## Written Submission to Committee of the Whole (Public Meeting), January 19, 2021, Item 5 – 7080 Yonge Limited

Respectfully submitted by Jordan Max, President of the Springfarm Ratepayers Association

We appeared before Council last July in response to the two redevelopment proposals for 100 and 180 Steeles Avenue West. This submission is about Chestnut Hill's proposal for 7080 Yonge Street, with two high-rise residential towers, one 20 storeys and the other 40 storeys on top of a 2-storey podium. However, there are many similarities.

Figure 1- Architect's rendering of proposed redevelopments at Yonge & Steele (source Humboldt Properties)

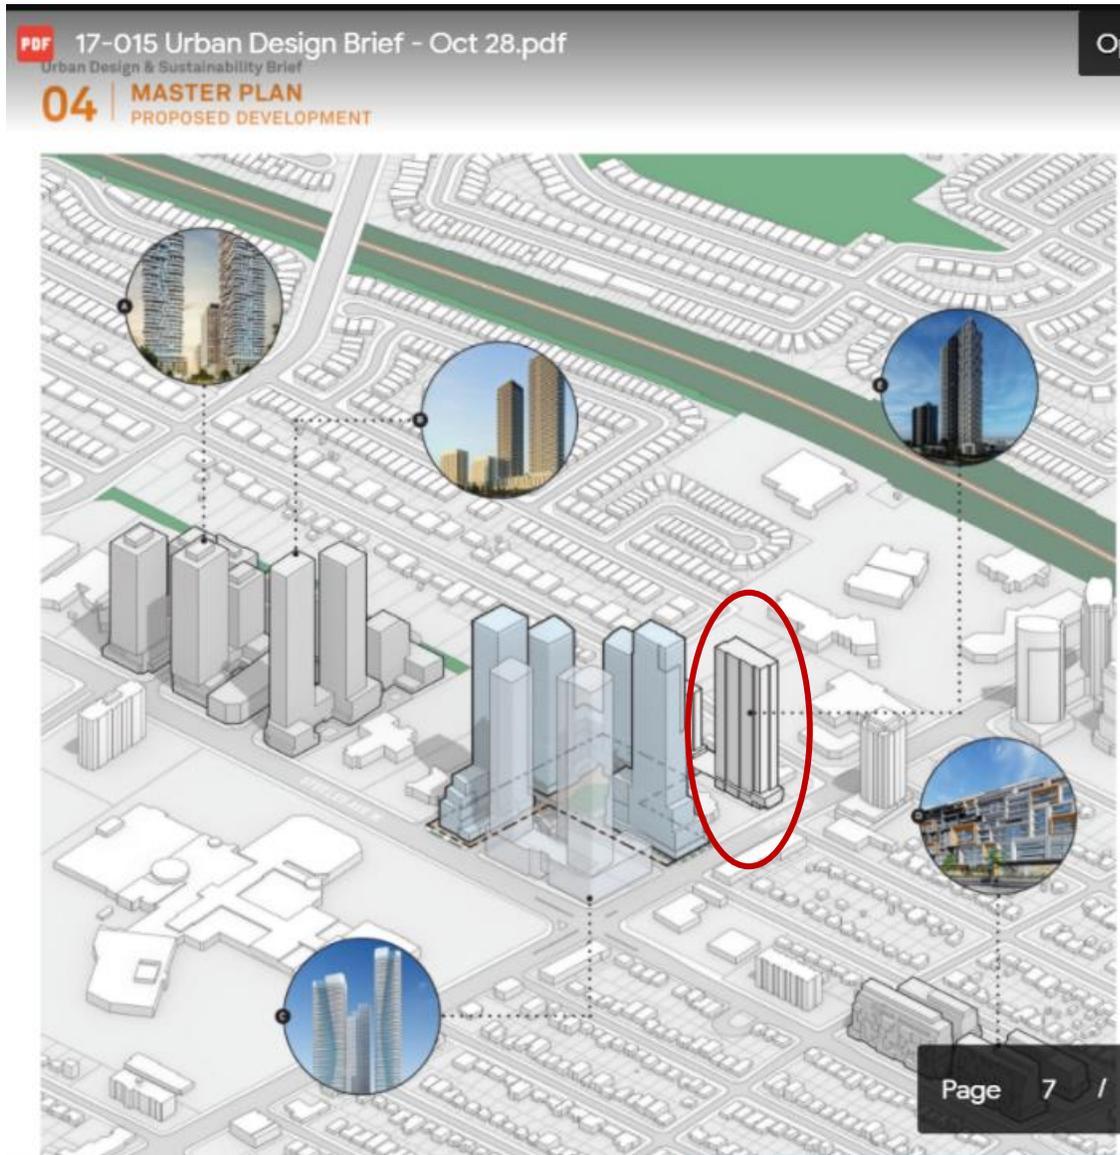
development proposals submitted to the City. There is now a total of **19 buildings** proposed for the west side of Yonge Street and north side of Steeles Avenue West. The schematic inside the highlighted oval is 7080 Yonge Street.

Figure 2- close up Secondary Plan Schedule 2 (7080 Yonge marked in dashed line)

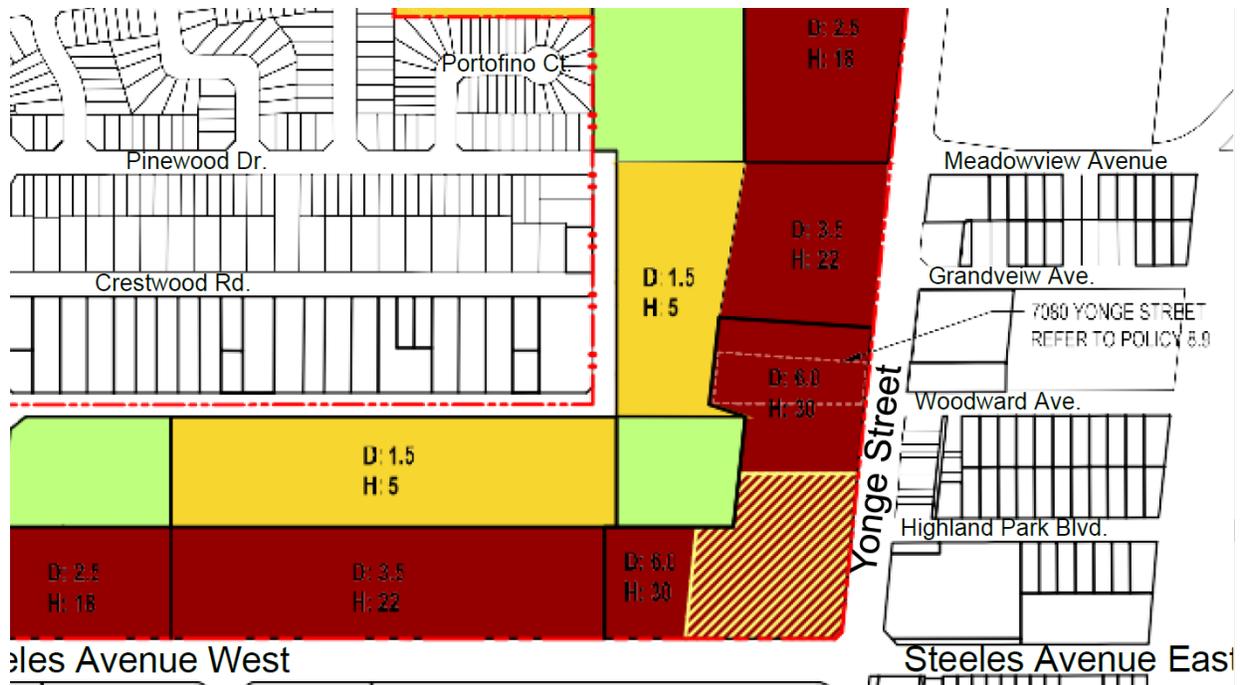
Figure 2 shows the maximum height of 30 storeys for high-rise mixed residential use at the northwest corner of Yonge and Steeles (shaded red), tapering west down to 22 storeys), with densities from 5.0 to 3.5 respectively, and a 5-storey mid-rise residential density of 1.5 (shaded orange).

The Secondary Plan (section 8.9) also contained special site-specific provisions for 7080 Yonge, noted in the dashed line in Figure 2. They were approved in 2016 and have not been appealed to LPAT, so they are fully in effect and binding. Since the allowed FSI is 6.0, it would indicate that section 3.6.11, designating the site as an “Office Priority Area” would also apply.

Figure 3 – Vaughan Urban Design Guide – Standard 5.3.6 (page 134)

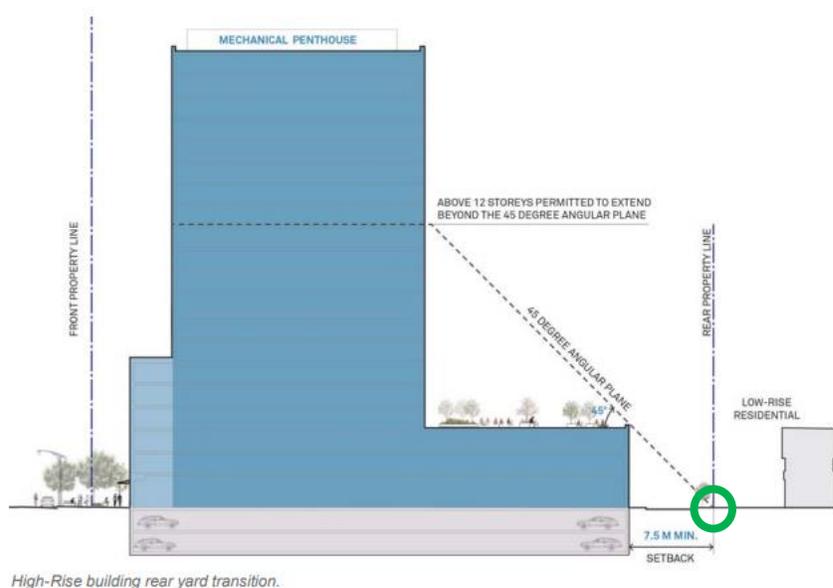
The architectural drawings do not illustrate the 45-degree angular plane from the rear property line required in the City’s Design Review Guidelines (see Figure 3) to transition to the residential neighbourhood to the west.

and the smaller tower is 20 storeys, both towers are therefore high-rise. Therefore, we submit that there must be a 7.5m setback to the property line, as illustrated in Figure 3. (The Zoning By-Law amendment proposal requests only a 1.55m setback, which is clearly insufficient for a number of reasons which we will explain.)

Figure 4 – 45-degree angular plane projection (supplied by the Agent) and SFRA projection (red dashed line)

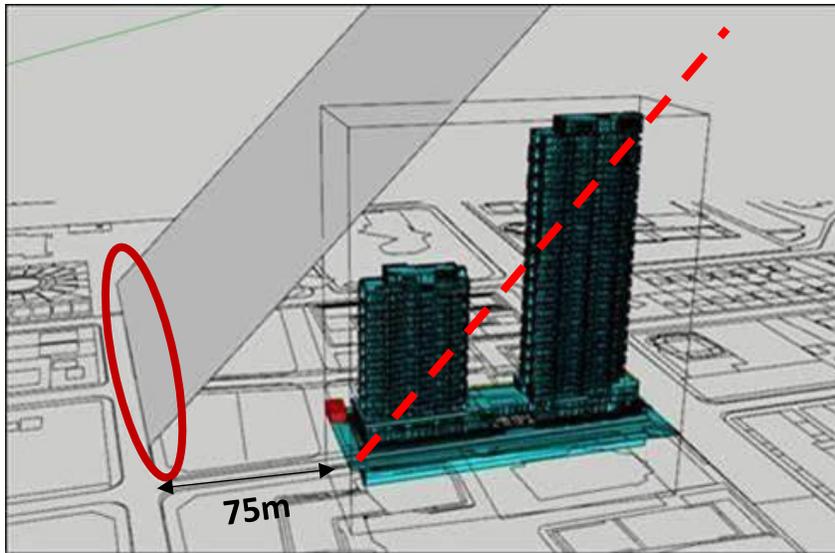
However, an illustration subsequently provided directly to SFRA by the agent (see Figure 8 below) indicates that the 45-degree angular plane starts at the eastern side of the southern extension of Powell Road, 75 metres to the west (red oval). The problem with that is that there are four properties between Powell and the western boundary of the site, and they have not been purchased by Chestnut Hill to be added to the site, thus in reality the 45-degree angle would start at the western boundary of the site, (our dashed parallel red line) which would intersect the first building at 1 storey and the second at about 18 storeys. Moreover, if the developer followed the Secondary Plan for publicly accessible green space (10m), [see next section], the property line would be 10 metres further to the east, which would further reduce the height intersect of the second building.

The developer claims that the area between the southern extension of Powell Road and their site is designated in the Secondary Plan for mid-rise development and that therefore the 45-degree angular plane should start at Powell Road. There are two problems with that; first, this proposal does not include the four properties between itself and the future Powell. Secondly, the developer cites the validity of the Secondary Plan when it is convenient for him, but at the same time he notes that the Secondary Plan is not yet in effect. **The developer can't have it both ways.** If he wants to use Powell Road as his property line, then he needs to buy the four properties to the west, expand his site, and redevelop them as mid-rise buildings. He has not done that. He cannot justify the building heights using the 45-degree angular plane on the basis of another development that has yet to materialize. Furthermore, if he respects the Secondary Plan, he should also not encroach on the designated green park space for starters. We have no guarantees about the future redevelopment of the four properties between this site and Powell Road, so Council can only deal with what is in this site proposal.

Figure 5 – Yonge Steeles Corridor Secondary Plan Schedule 4 (Parks and Publicly Accessible Open Space)

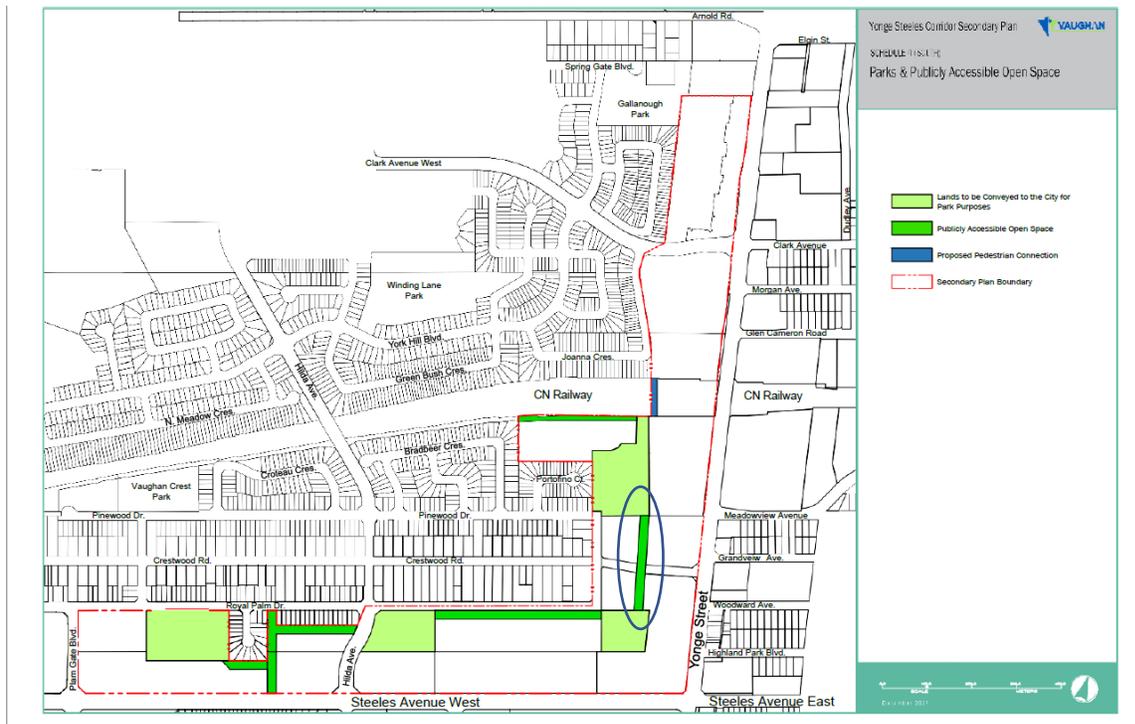
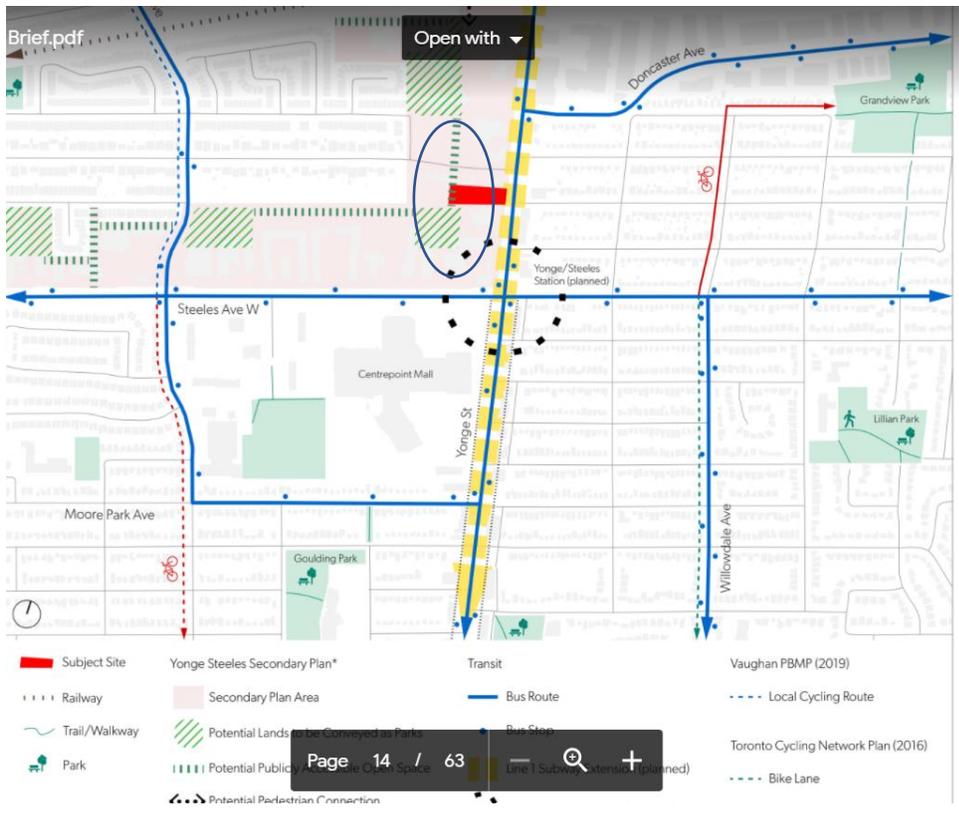
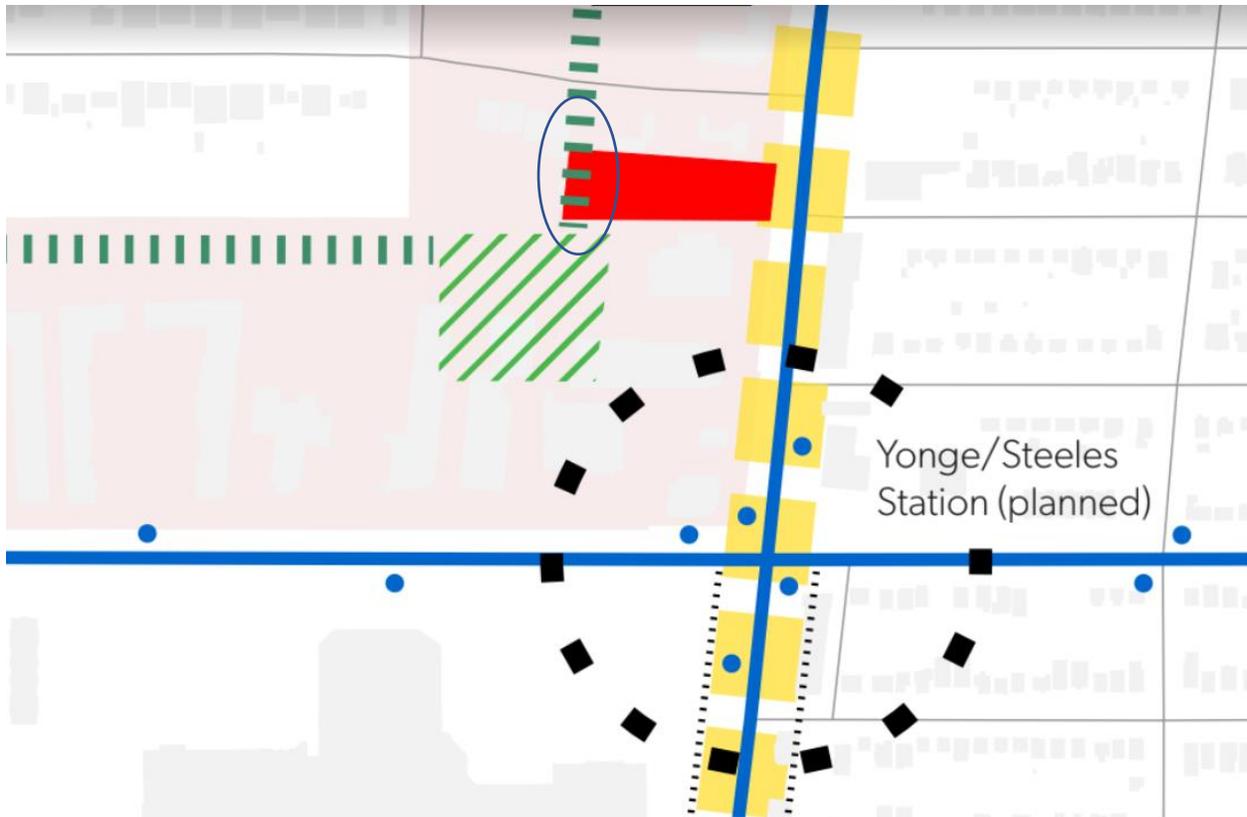
The transition is nonexistent; it is abrupt. **In fact, it actually builds over a 10m wide segment of land designated in the Secondary Plan for a “publicly accessible open space” linear park.** (see Figures 5, 6 and 7 below, inside the blue oval) The Planning Justification Report is silent on this major detail, and does not draw attention to it, let alone attempt to justify it. The intrusion to the green space park only shows up in Figure 5 of the Urban Design Brief, but again there is no textual reference to it there either. There is no green buffer between the houses to the west and the proposed 20-storey building, and most of the green space is private green roof on the podium for the exclusive use of the buildings’ residents.

Figure 8 – Population Density for Yonge-Steeles area, 2016 (Source: [www.censusmapper.ca](http://www.censusmapper.ca))

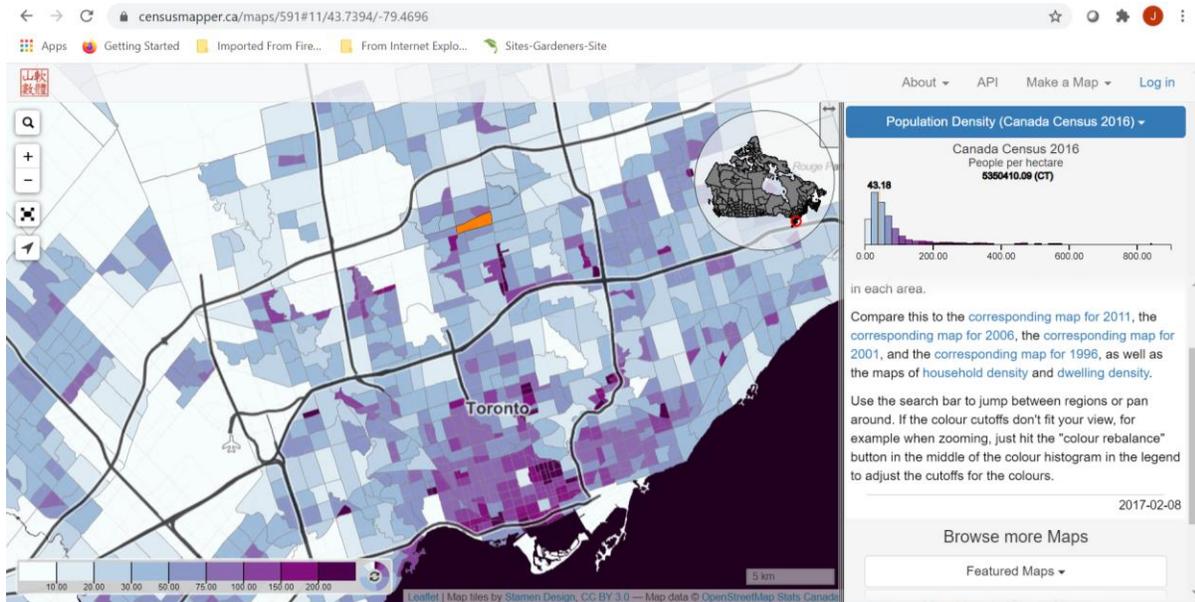
The current area Population density shown below in Figure 8 (in orange) is 43 persons/hectare. The proposed population density (persons per hectare) for 7080 Yonge Street is 652 units x average 1.5 pph/0.5 ha = 1,956 pph, which is 4,548 percent greater than the current density level. If approved as is, this site would become the **second most dense** population site in the entire GTA (the highest, at 2,215 pph, is Metropolis Suites at Peter and Adelaide Street in downtown Toronto, as seen in Figure 9. So, one gets a sense of just how out of proportion this development is for a site of this size.

Figure 10 Lot Coverage and Setbacks (source: 7080 Yonge Limited – Architectural Drawings, p. 4)

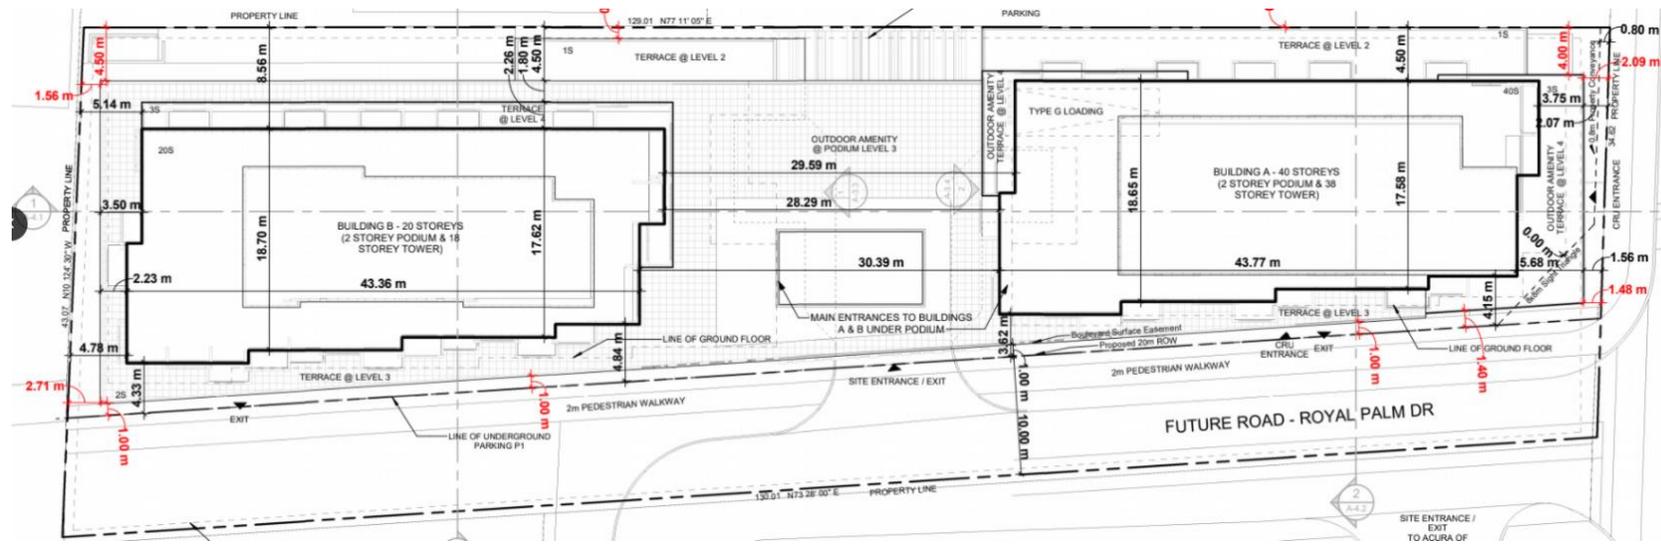
Figure 10 illustrates that the buildings use up approximately 3883/5016m<sup>2</sup> (78%) of the property (including landscaping (Urban Design Brief, Table 2, p. 25)). If we include the private driveway between the buildings of an estimated 905m<sup>2</sup>, the lot coverage is closer to 90-95%. The proposed setbacks from public to private space are 1.48-2.09m on Yonge Street (compared to 7.5m for an RA3 zoning designation the proponent seeks, 0m on the north side (vs. 7.5 for an RA3), 1.0m on the south side (vs. 7.5 for RA3) and 1.56-2.71m on the west side (vs. 7.5m for RA3).

Figure 12 – Shadow Study (Urban Design Brief, p. 59)

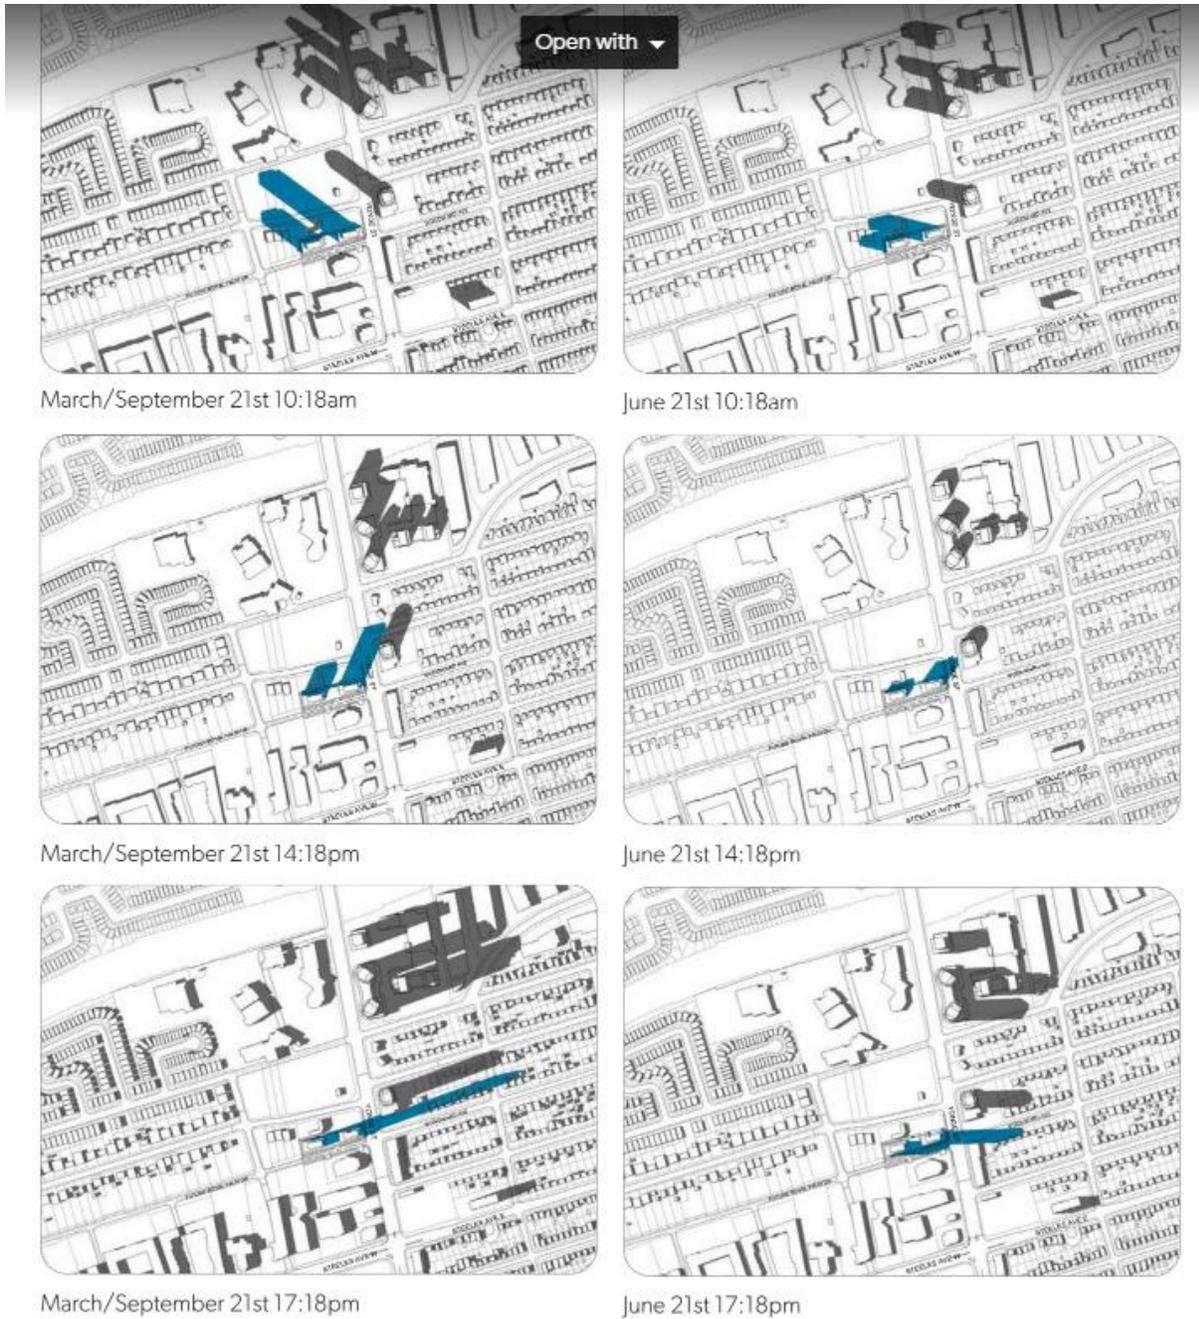
Shadows accrue from building height, massing and siting. The shadow study included in the Urban Design Brief (p. 59) shows strong east-facing shadows onto the Markham side of Yonge Street for March and September at 5: 18pm (see Figure 12)
